**SUBJECT:** Roundtable Response Package to FAA Initiative Results to Address Noise Concerns

Re: FAA Initiative Phase 1, SFO Airport/Community Roundtable Response

# EXPANDED PROCEDURE DISCCUSION PACKAGE SFO AIRPORT/COMMUNITY ROUNDTABLE RESPONSE TO FAA INITIATIVE

Woodside and Peninsula Flight Tracks

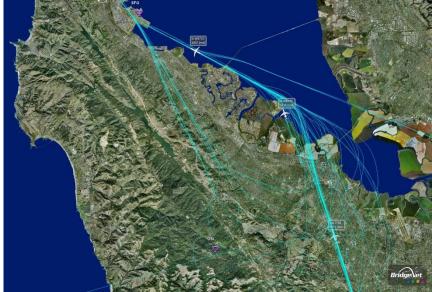
- 2. BDEGA Arrivals from the North: The SFO Roundtable is available to provide data to the FAA regarding terrain and land use for aircraft arriving on the BDEGA east leg and can work with the FAA to move the east downwind leg of the arrival over compatible land uses. In order to reduce vectoring on the Peninsula, the SFO Roundtable requests the FAA to increase in-trail spacing on the SERFR Arrival, on the DYAMD Arrival (to allow an increase in the BDEGA East Downwind, and determine if an increase in the BDEGA in-trail spacing would decrease vectoring.

- 1. The SFO Roundtable is available to provide data to the FAA regarding land use areas to assist in keeping procedures over compatible land uses as much as feasible during the day. The goal during the nighttime hours is to avoid flight over noise-sensitive land uses as much as feasible, even if it means a few additional track miles.

- 3. The SFO Roundtable will work with airline representatives to request that during the night time hours, airlines file oceanic flight plans that follow the path of BDEGA arrival for an FAA assigned east downwind for Runway 28R (down the Bay procedure) instead of flying over the peninsula.

- 5. The SFO Roundtable requests that NCT update its SOP to reflect using a "down the Bay" procedure is preferred during nighttime hours.

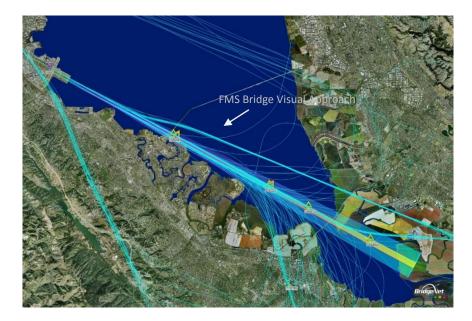
- 1. Determine if the BDEGA transition to FINSH can be reinstated. If so, determine a timeline for this revised procedure to be included for publication.

- 2. The SFO Roundtable requests that the FAA research to compare the previous Golden Gate arrival with the current BDEGA arrival to determine what changes have been made in actual flight tracks with regard to location of lateral paths, narrowing of path and concentration of aircraft. The previous Golden Gate arrival directed aircraft to fly a 140° *heading* after SFO/BRIXX, but the BDEGA directs aircraft to fly a 140° *track* after BRIXX. While this change seems minor flying a track instead of a heading it would result in a more concentrated invariable path, contrasted with using a heading, which, depending on the direction and velocity of wind could create somewhat dispersed paths.

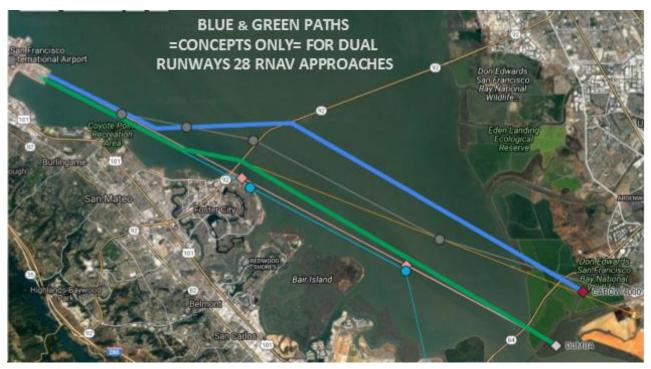
- Dual Visual Approaches: Whenever there are arrivals to both Runway 28L and 28R, and VMC conditions allow, aircraft for Runway 28R should be assigned to fly the FMS Bridge Visual Runway 28R or RNAV (RNP) Runway 28R (as capable), Quiet Bridge Visual or other noise friendlier approach to land on Runway 28R.

Research the feasibility of creating dual offset RNAV, RNAV (RNP) or other type of approach to Runway 28L and to Runway 28R which would create two offset paths closer to the middle of the Bay with both Runway 28L path and 28R path remaining well clear of Foster City and other bayside communities until past the San Mateo Bridge when aircraft would then line up with each runway for landing. Attachment B: Expanded Procedure Discussion Package Response to the *FAA Initiative to Address Noise Concerns* November 2, 2016 Page 10 of 32

# NIITE Southbound Transition & NIITE Departure with Runway 10 takeoffs authorized:

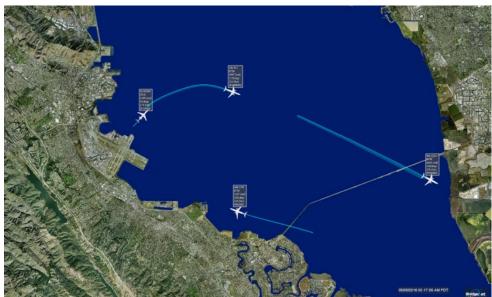
1. NIITE Southbound Transition: The SFO Roundtable is in agreement with FAA *Initiative* Adjustment 2.f.i and formally requests that the FAA add a transition to the NIITE departure for southbound aircraft.

Without presuming to technically design such a south transition, it would seem that this highly desirable southbound destination transition *might* be comprised of a single, simple "add-on" leg, using the existing NIITE departure to the GOBBS waypoint, and thence via already largely existing waypoints and flight paths mirroring much of the PORTE departure to PORTE intersection. In addition, the routing of the OFFSHORE departure may present an additional option. The SFO Roundtable understands that the design of professional flight procedures encompasses far more than a line drawn on a map, and understands that airspace use and airspace restrictions are significant challenges in this process.

The possible southbound transition for the NIITE departure depicted above contains just two concepts to consider. The "add-on" paths depicted seem desirable not only because they keep aircraft largely over the Pacific Ocean, but also because a significant portion of the "add-on" paths are routinely used in the

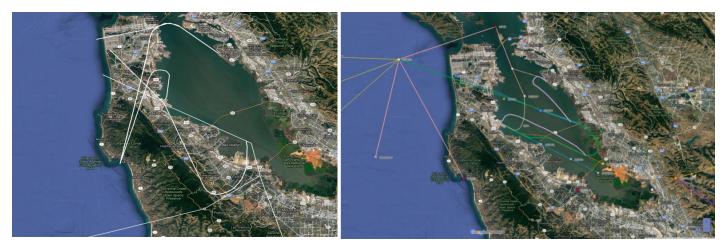
- It should be determined if any VFR flyway results in Runway 28 straight-out departures being assigned a 3,000' altitude restriction. If so, determine if a modification of any VFR flyway is warranted in the current Class B Airspace Modification process to allow unrestricted climbs for SFO Runway 28 jet traffic. If the altitude restriction is due to other factors, determine if the other factors can be modified to allow unrestricted climb.
- 2. Create a procedure that includes the ability of aircraft to depart Runway 10 L/R on a heading that isn't in the direct path of aircraft arriving on Runway 28, such as making an immediate left turn after takeoff or flying to the east of the Runway 28 arrival path to provide lateral separation; for vertical separation, use altitude restrictions for the departing aircraft.
